February 1, 2008

Subject:Responses to Comments on the Work Plan for East Ravine GroundwaterInvestigation, PG&E Topock Compressor Station, Needles, California

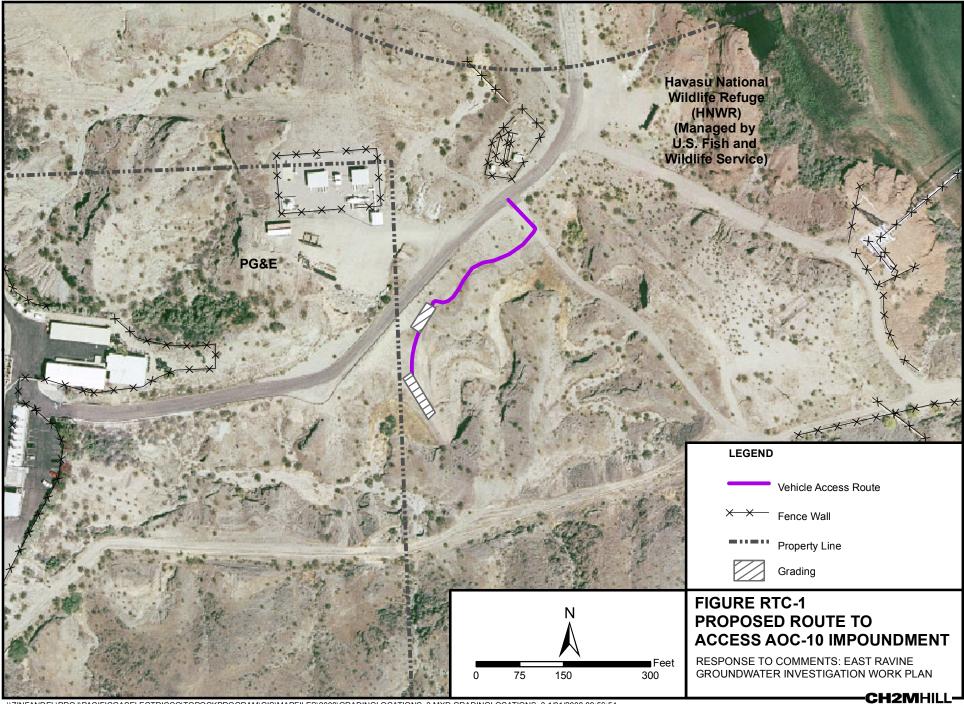
2. <u>Comment:</u> Regarding Section 2.1, Investigation Overview: EMC believes that more initial drilling locations, including drilling immediately next to the impoundment, are required (EMC, 2007). The GSU understands that drilling adjacent to the impoundment was not considered by PG&E due to physical constraints posed by the ravine topography. However, PG&E should further evaluate completing wells within or immediately adjacent to the former impoundment as installing wells adjacent to potential source areas is generally beneficial in evaluating if a former unit has impacted the environment. If it is feasible to install a well in or adjacent to the former impoundment, it is recommended that the well be included in the Work Plan as an initial well.

<u>Response</u>: PG&E understands that, in response to this comment, DTSC is requesting that PG&E provide additional information about the technical feasibility of accessing this location for installation of a well group within the former impoundment (AOC -10c). Grading and filling will be required to gain access to the former impoundment with the required drilling equipment.

The proposed equipment access pathway would parallel the southern side of the paved roadway from the AOC-10d sub area to the impoundment east of the AOC-10c sub area. Approximate areas requiring modification, which are depicted on Figure RTC-1, include the following:

- Grading and filling of a depressed area with moderately steep slopes to the northwest of sample location AOC-10d. The area requiring modification is approximately 50 feet long by 20 feet wide.
- Cutting and grading of a pathway down the western side (northwest to southeast) of the impoundment immediately east of the AOC-10c sub area. The area requiring modification is approximately 75 feet long by 20 feet wide.
